# 6575A-10

# S E R V I C E N O T E

## 6575A DC POWER SUPPLY, 0-120V, 0-18 A, 2100 W. MANUALLY CONTROLLED.

**Figure 3** Regal Non locking Nut

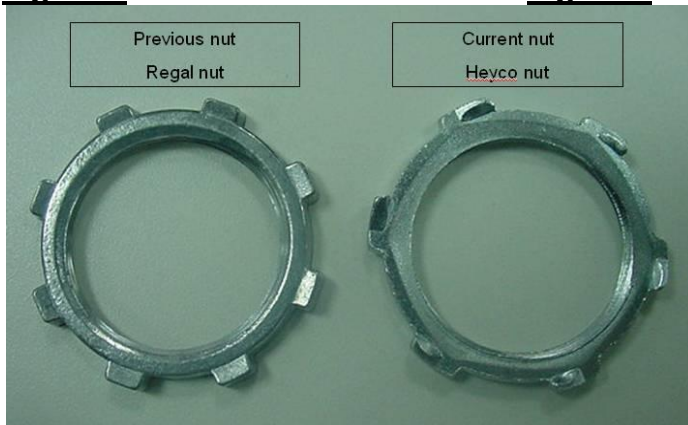
Figure 2 shows the inside of the AC Safety Cover housing the incorrect hardware is shown. It will be very difficult to tighten the strain relief. AMC (Asian Manufacturing Center) uses a special tool to tighten the locking nut. When the incorrect nut is used or a locking Nut is put on incorrectly the strain relief will become loose as described above.

Figures 3 & 5 is representative of a not without locking ribs.

The entire **AC INPUT SAFETY COVER** P/N 5040-1676 should be replaced.
